**FORM VT-3C**  
**CONTAINMENT INSERVICE INSPECTION**  
**RECORD OF VT-3C EXAMINATION**

STATION/UNIT: Indian Point 2 COMPONENT NO.: VCC-26  
 ZONE NUMBER: IWL-128-003 DRAWING NO.: 320860  
 EQUIPMENT USED: Celestron Giant 20x80 Binoculars (Ser. No. 990176)

**FORM VT-1C**  
 CONTAINMENT INSERVICE INSPECTION  
 RECORD OF VT-1C EXAMINATION

**CONCRETE INSPECTION ZONE IWL-128-003**  
 (EXTERIOR DEVELOPED VIEW, LOOKING FROM OUTSIDE)

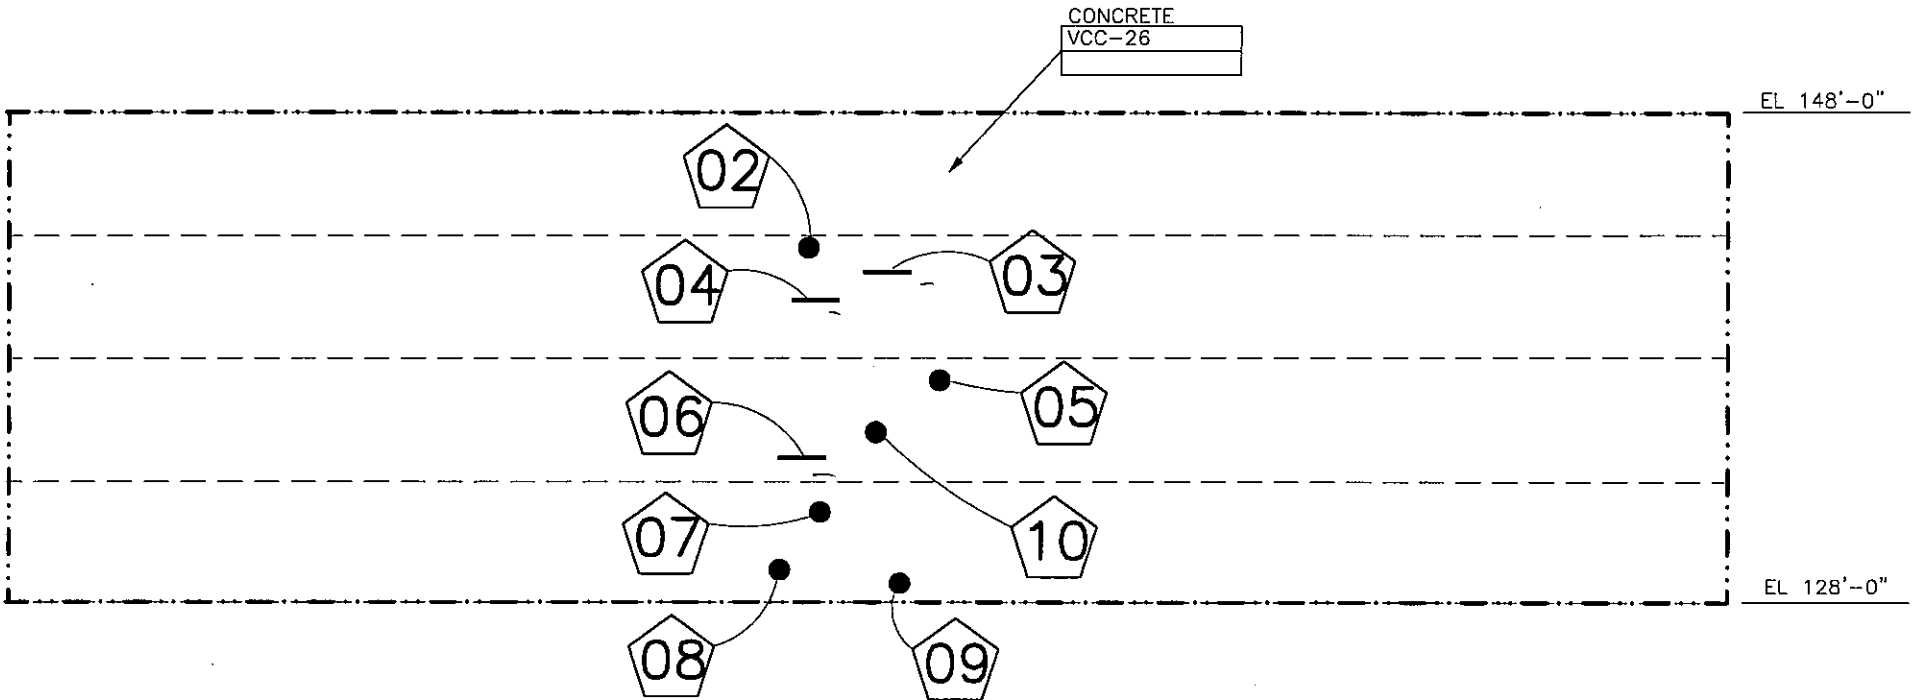
No.	Comment	Initials
1	Non-uniformity of surface color and texture observed at various locations in the zone. The condition does not indicate significant material deterioration of the concrete.	RN
2	Delamination of concrete cover over 2" length. See photo 00053105	RN
3	10"x4" concrete spall exposing cadweld sleeve. See photo 00053106 and 00053107	RN
4	2 closely spaced spalls about 8" in diameter about to pop out exposing steel. See photo 00053108	RN
5	leaching in the form tie hole patch area	RN
6	4"x2" opening in concrete exposing cadweld sleeve. See photo 00053110	RN
7	1" dia void in concrete exposing rebar. See photo 00053111	RN
8	concrete cover about to spall in a 6"square surface. See photo 00053112	RN
9	concrete cover about to spall in a 6"square surface	RN
10	concrete cover about to spall in a 6"square surface. See photo 00053109	RN

Comments: The leaching (comment #5) is not significant. The surface texture (comment #1) resulted from original construction and does not reflect degradation of the containment. Engineering evaluation is needed for all of the other comments, which relate to rebar corrosion.

**CONCRETE INSPECTION ZONE IWL-128-004**  
 (EXTERIOR DEVELOPED VIEW, LOOKING FROM OUTSIDE)

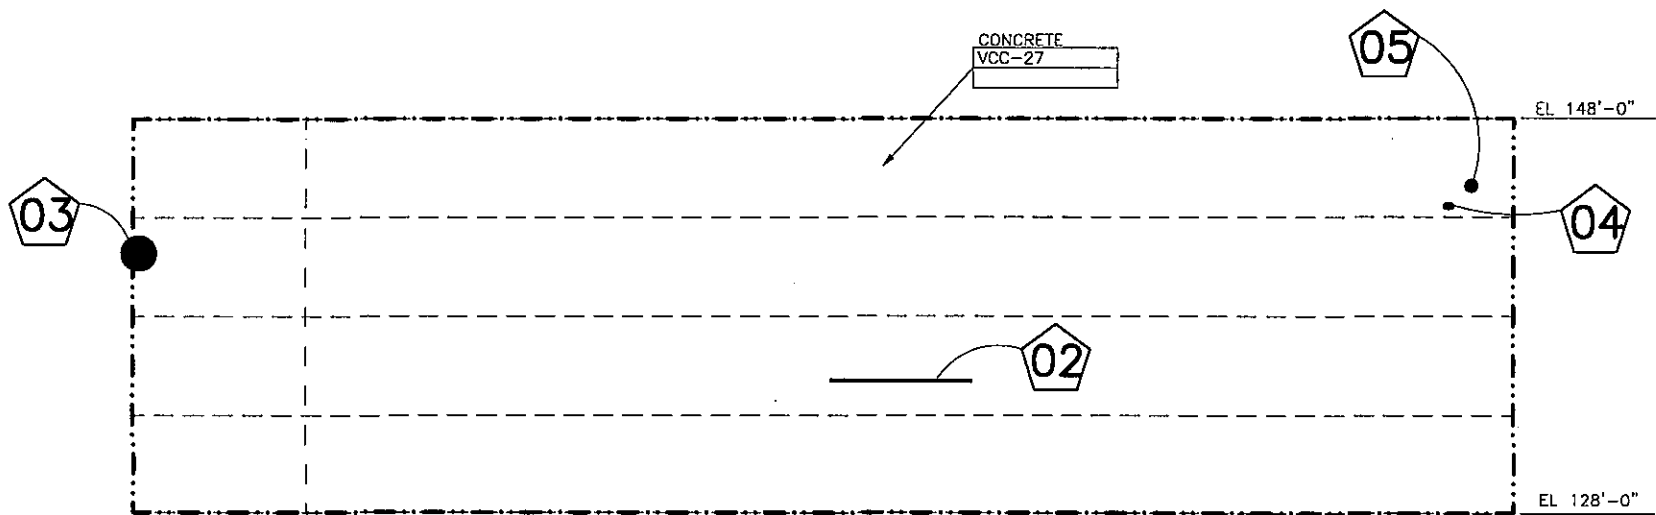
No.	Comment	Initials
1	Non-uniformity of surface color and texture observed at various locations in the zone. The condition does not indicate significant material deterioration of the concrete.	RN
2	Loss of mortar 1/4" deep over an area 2' x 6". See photo 00052624	RN
3	2" rebar steel exposure due to cover concrete spalling. See photo 00052625	RN
4	Exposed and corroded rebar. See photo 00060120	RN
5	The concrete has cracked & bulged in a small area that is likely to spall off. By comparison to other similar areas it is believed to be a cadweld or reinforcing steel which is corroded due to insufficient concrete cover. See photo 00060120	RN

Comments: The surface conditions (comments #1 & #2) resulted from original construction and do not reflect degradation of the containment. The other conditions (comments #3, #4 & #5) involve rebar corrosion and require engineering evaluation.

**CONCRETE INSPECTION ZONE IWL-128-006**  
(EXTERIOR DEVELOPED VIEW, LOOKING FROM OUTSIDE)

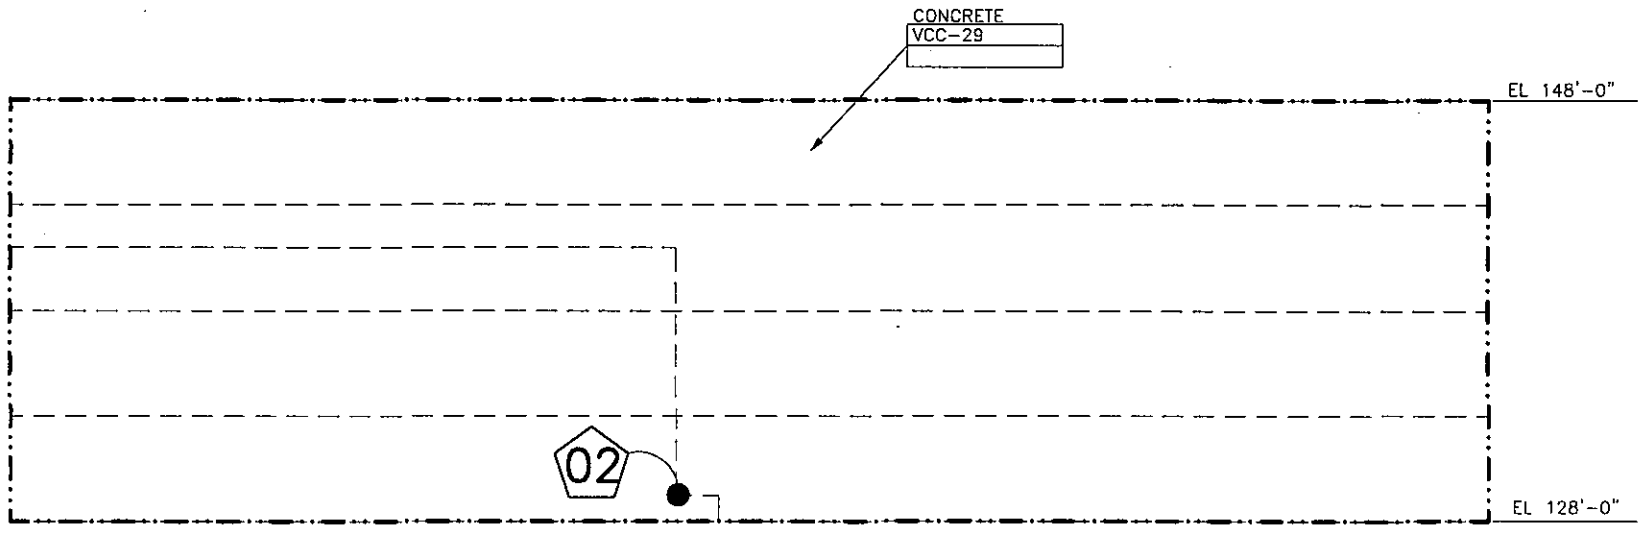
No.	Comment	Initials
1	Non-uniformity of surface color and texture observed at various locations in the zone. The condition does not indicate significant material deterioration of the concrete.	RF
2	White deposit (Efflorescence) from a 6" square area of concrete cover patch. See photo 00052610	DN

Comments: The leaching is not significant. The surface texture resulted from original construction and does not reflect degradation of the containment.

**CONCRETE INSPECTION ZONE IWL-148-001**  
 (EXTERIOR DEVELOPED VIEW, LOOKING FROM OUTSIDE)

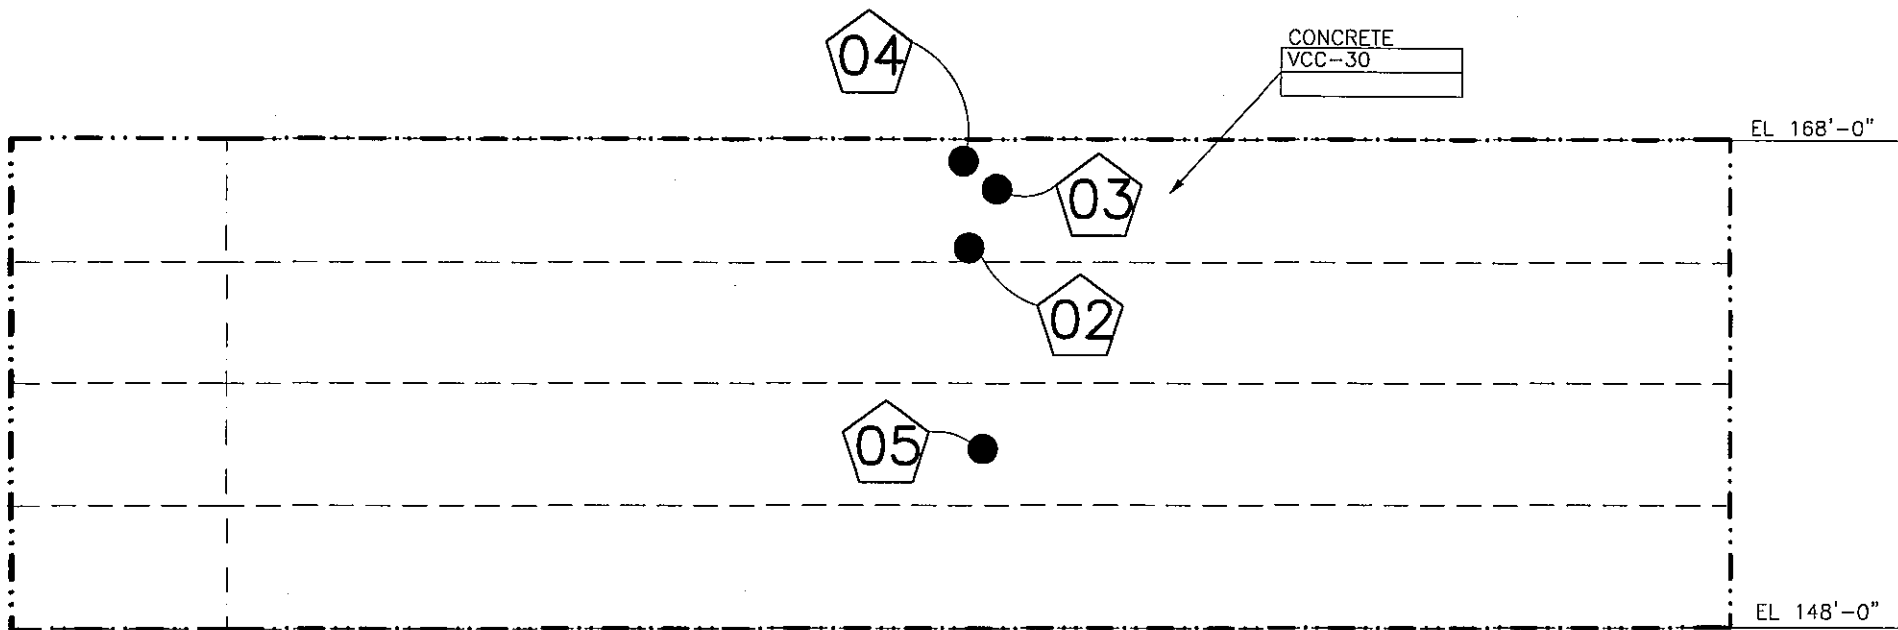
No.	Comment	Initials
1	Non-uniformity of surface color and texture observed at various locations in the zone. The condition does not indicate significant material deterioration of the concrete.	CAS
2	Cadweld exposed & corroded due to loss of concrete cover. See photo 00053146	CAS
3	Cadweld exposed & corroded due to loss of concrete cover. See photo 00053147	CAS
4	Cadweld exposed & corroded due to loss of concrete cover. See photo 00053147	CAS
5	The concrete has cracked & bulged in a small area that is likely to spall off. By comparison to other similar areas it is believed to be a cadweld or reinforcing steel which is corroded due to insufficient concrete cover. See photo 00053148	CAS

Comments: The surface texture (comment #1) resulted from original construction and does not reflect degradation of the Containment. The other conditions (comments #2 - #5) involve corroded reinforcing steel and require engineering evaluation.

**CONCRETE INSPECTION ZONE IWL-148-002**  
(EXTERIOR DEVELOPED VIEW, LOOKING FROM OUTSIDE)

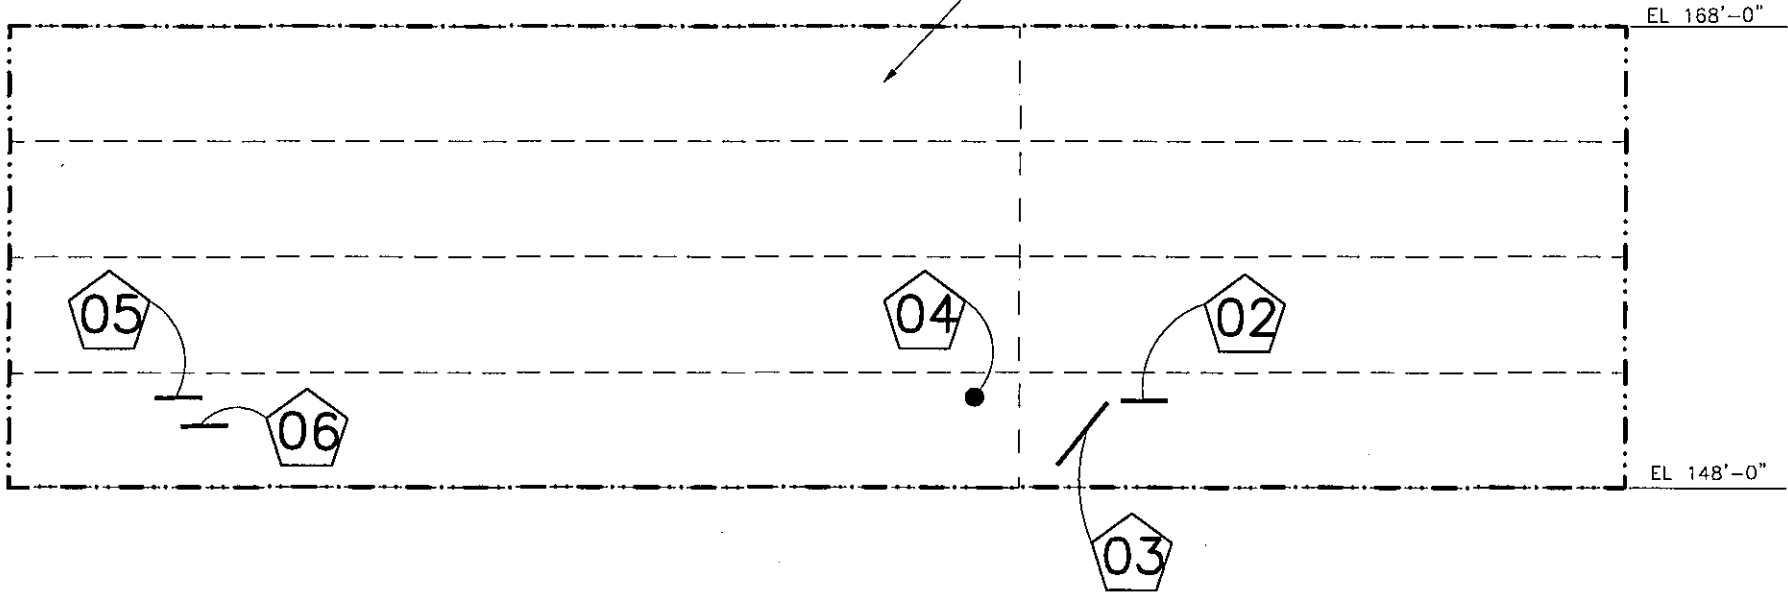
No.	Comment	Initials
1	Non-uniformity of surface color and texture observed at various locations in the zone. The condition does not indicate significant material deterioration of the concrete.	CAS
2	Exposed steel is corroded and appears to be rebar. See photo 00053138	CAS
3	A piece of steel, not reinforcing steel, is exposed at the concrete surface on a diagonal line approximately 3' long. See photo 00053140	CAS
4	A small spot of steel is exposed and corroded. It does not appear to be reinforcing steel. See photo 00053141	CAS
5	Cadweld exposed & corroded due to loss of concrete cover. See photo 00053149	CAS
6	Cadweld exposed & corroded due to loss of concrete cover. See photo 00053149	CAS

Comments: The surface texture (comment #1) resulted from original construction and does not reflect degradation of the containment. The exposed & corroded reinforcing steel (comments #2 - #6) require engineering evaluation.

**CONCRETE INSPECTION ZONE IWL-148-003**  
 (EXTERIOR DEVELOPED VIEW, LOOKING FROM OUTSIDE)

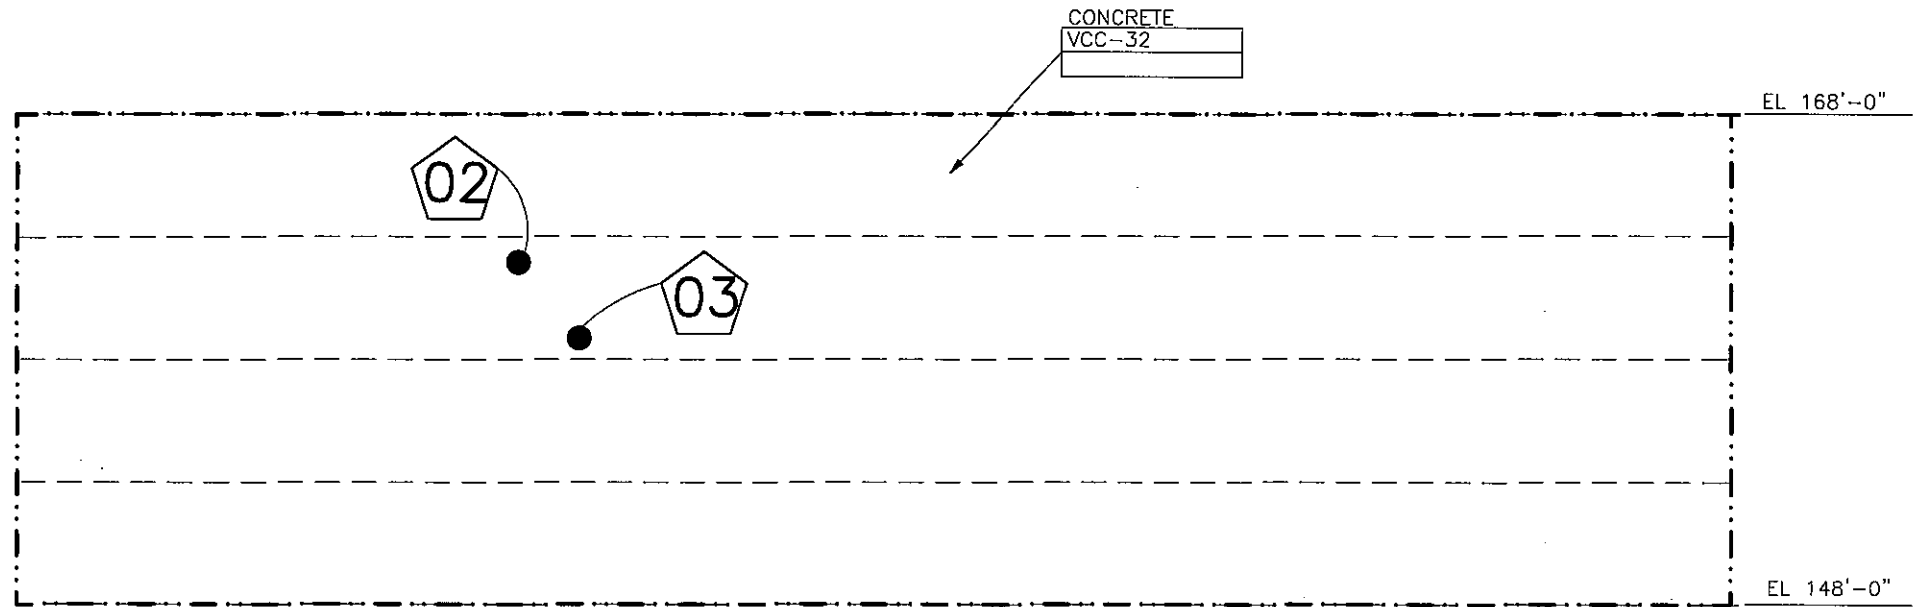
No.	Comment	Initials
1	Non-uniformity of surface color and texture observed at various locations in the zone. The condition does not indicate significant material deterioration of the concrete.	CAS
2	A small spot of steel is exposed and corroded. It is not immediately apparent whether it is reinforcing steel but it is similar in appearance to cadwelds exposed in other areas. See photo 00053133	CAS
3	A small spot of steel is exposed and corroded. It is not immediately apparent whether it is reinforcing steel but it is similar in appearance to cadwelds exposed in other areas. See photo 00053134	CAS

Comments: The surface texture (comment #1) resulted from original construction and does not reflect degradation of the Containment. Engineering evaluation is needed for the rust staining that is potentially from corroded rod welds.

**CONCRETE INSPECTION ZONE IWL-148-005**  
 (EXTERIOR DEVELOPED VIEW, LOOKING FROM OUTSIDE)

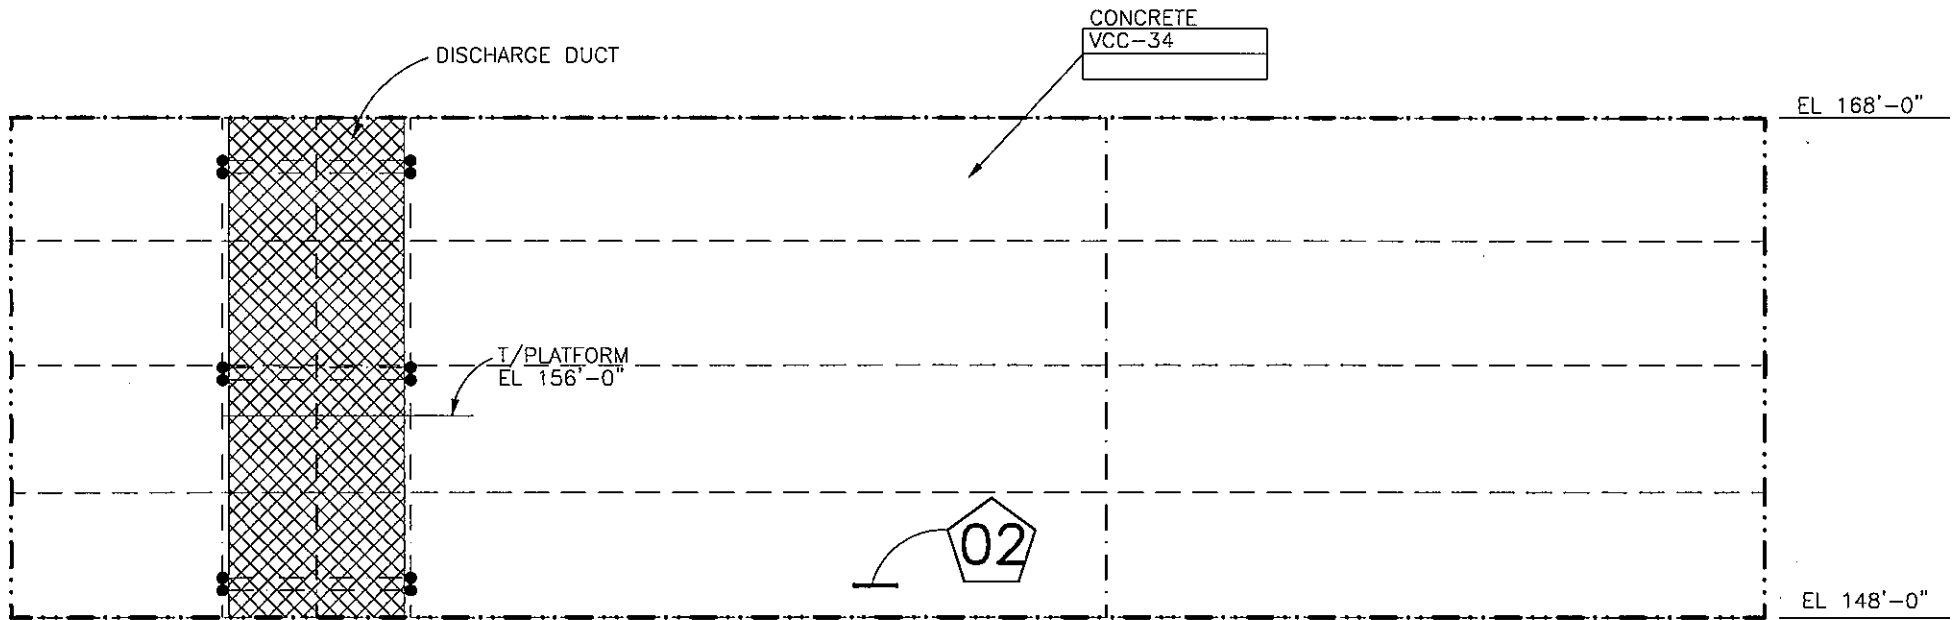
No.	Comment	Initials
1	Non-uniformity of surface color and texture observed at various locations in the zone. The condition does not indicate significant material deterioration of the concrete.	CAS
2	Rebar exposed and corroded. See photo 00060102	CAS

Comments: The surface texture (comment #1) resulted from original construction and does not reflect degradation of the containment. Engineering evaluation is need for the exposed/corroded reinforcing steel.
